APPEAL SUMMARY

Appeal ID: 21894	Project Address: 151 SW 1st Ave
Hearing Date: 9/18/19	Appellant Name: Milena Di Tomaso
Case No.: B-009	Appellant Phone: 5038632425
Appeal Type: Building	Plans Examiner/Inspector: John Cooley
Project Type: commercial	Stories: 5 Occupancy: B ,M, S-1 Construction Type: 3-A
Building/Business Name: PAE Living Building	Fire Sprinklers: Yes - Throughout
Appeal Involves: Erection of a new structure	LUR or Permit Application No.: 19-185198-CO
Plan Submitted Option: pdf [File 1] [File 2] [File 3] [File 4]	Proposed use: Office, Retail

FLOOR PLAN - LEVEL 01

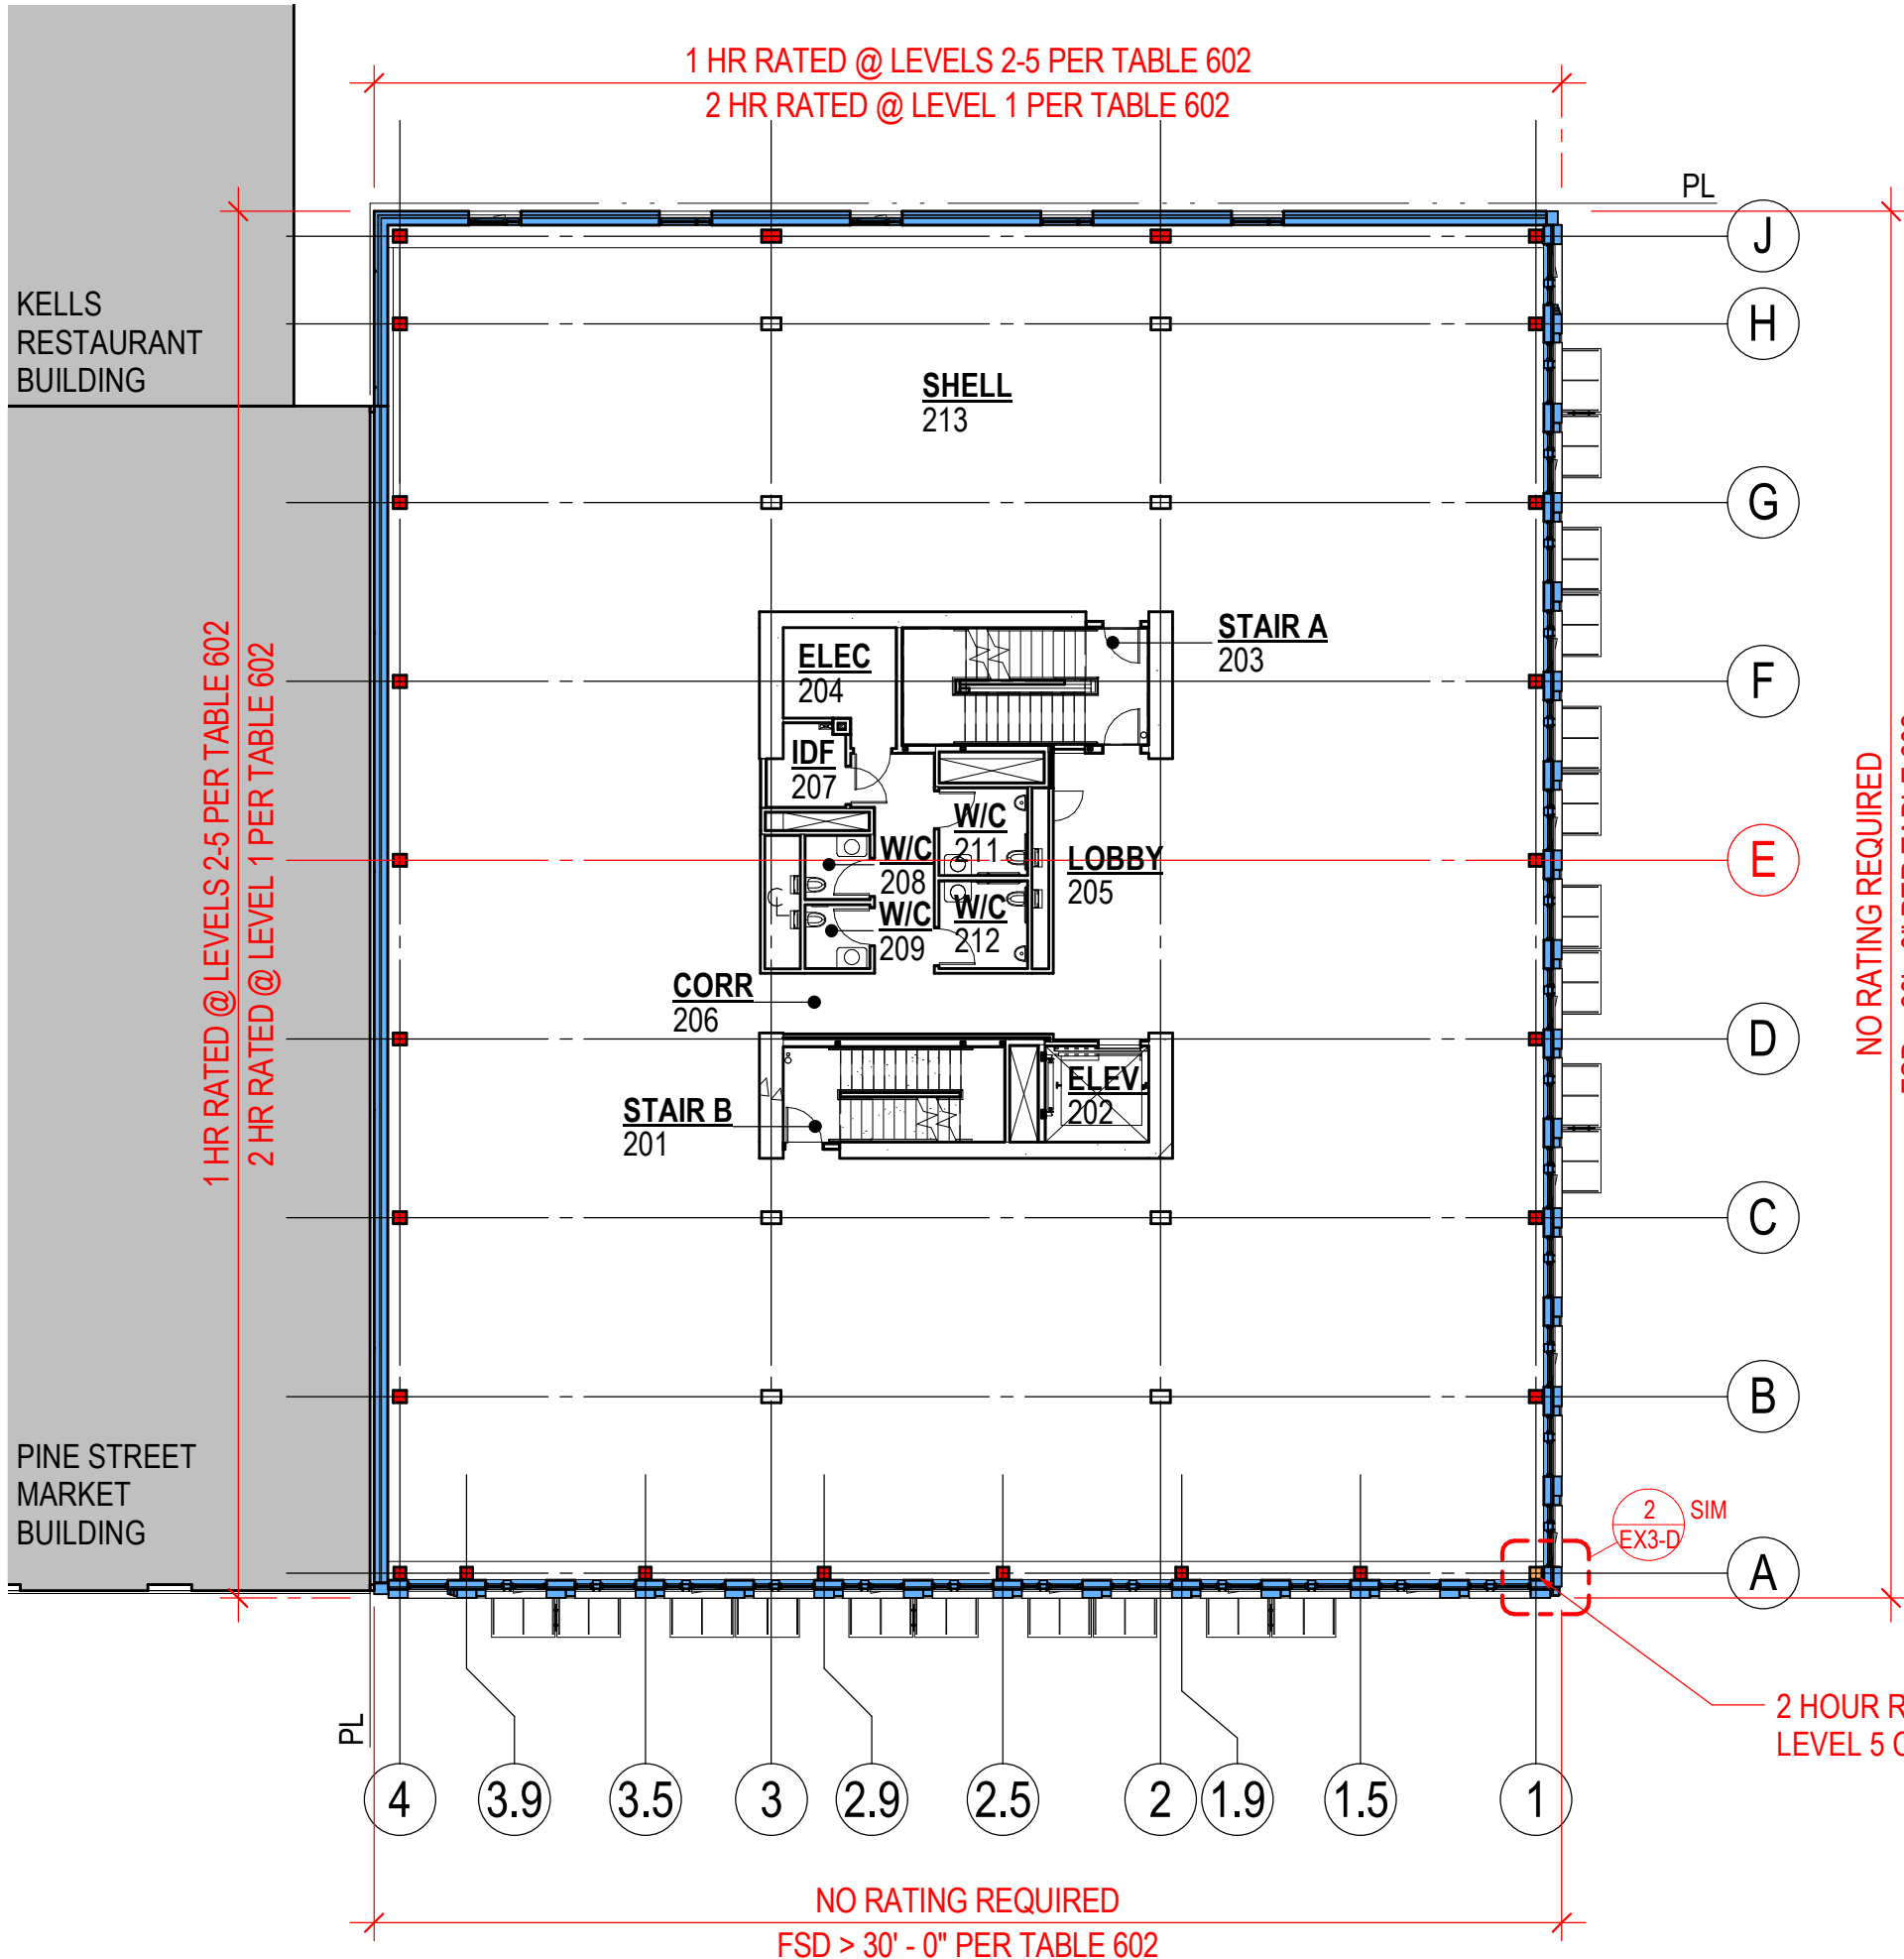
On levels 1 and 5 on the South and East exterior walls, there are recesses between the column bays. In those locations the structure is still completely on the inside of the inner most exterior wall layer, and per Table 601 will require 1-hour rating. We are proposing an additional layer of 5/8" type X gypsum board on the interior side at the walls surrounding the structure in order to provide a 2-hour rated exterior wall assembly. These locations only occur on the street facing walls with a fire separation distance of greater than 30', and the locations on the 5th floor are over 56' above grade level.

Reason for alternative The conditions addressed above and in the attached exhibits were identified as within the exterior wall during permit review and not compliant with the Section 704.10 of the building code, and as a result it was requested to provide 2 hour rated structural components where the setbacks occur on levels 1 and 5, and to continue the rating to any structural elements that support those elements.

In order to provide protection of the structure at these areas on the 1st and 5th floor, the two layers of 5/8" gypsum board on the interior side along with the brick masonry unit on the exterior side will provide a 2-hour rated equivalent exterior wall assembly. We feel the proposed design meets the intent of the code and protects the structure from exposure to fire.

3. Alternate 2 hour wall assembly: Hold for additional information.

FLOOR PLAN - LEVEL 05

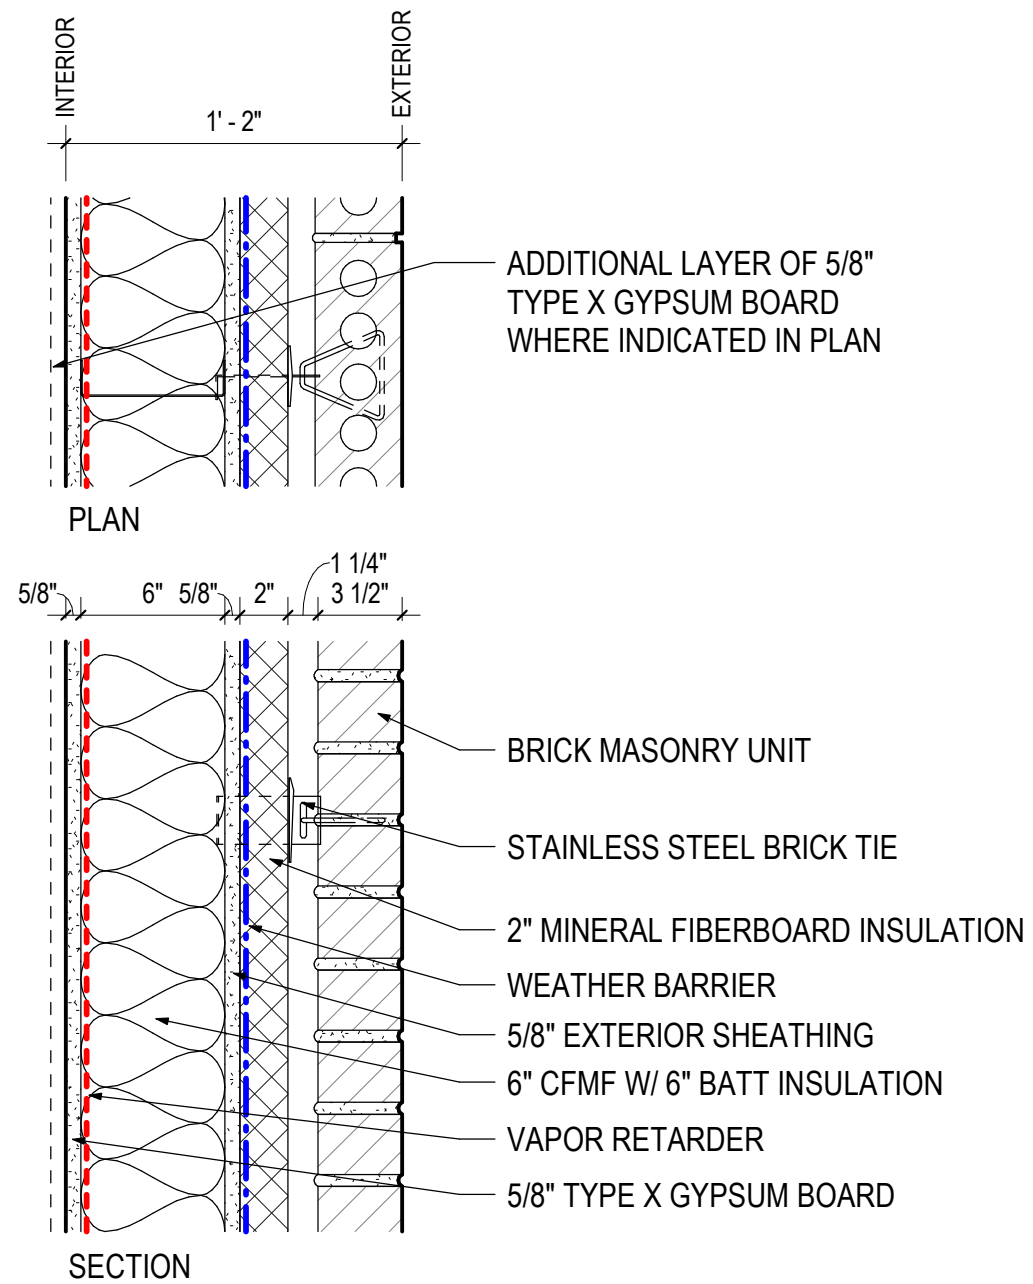
Proposed Design	<p>The PAE Living Building is a 5-story type 3A mixed occupancy building with Retail and Support spaces on the ground floor and Business occupancy on levels 2 through 5. The proposed design locates two A-3 assembly spaces (Main Conference Room and Multi-Purpose Room) on the 5th floor which total in excess of 10% of the floor area, so they cannot be considered accessory to the Business occupancy (per 508.2.1). We are proposing to install a 1-hour fire barrier partition on the 5th floor (per table 508.4) that will separate the assembly spaces from the remaining portion of the Business office spaces. The floor and roof structure below and above the assembly spaces will also be constructed to a 1-hour protective rating. The separate assembly space has direct access to a main exit Stair A, in addition to Stair B which will exit through the 1-hour fire barrier.</p>
------------------------	---
